P5020A-04

Information Only Service Note

P5020A Keysight Streamline USB Vector Network Analyzer

False alarm on self-test failure on firmware revision of A.13.40.02 - DDR3 memory removal

Self-test

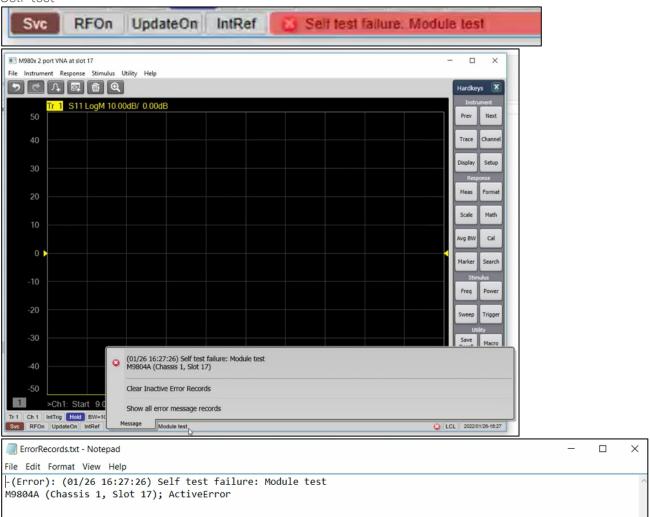
The on board DDR 3 memory in VNA is not in use since its release. With the removal of DDR 3 memory IC on newer P502xA VNA, right after firmware is launched, false alarm (self-test failure) will be reported as shown. This has no impact to VNA performance and specifications.

Similarly, firmware will report a false failure in Operator check. Shown are the error messages example on VNA firmware UI.

For users with firmware revision of A.13.40.02, Update firmware to revision A.13.70.02 or newer to resolve this false alarm on self-test.
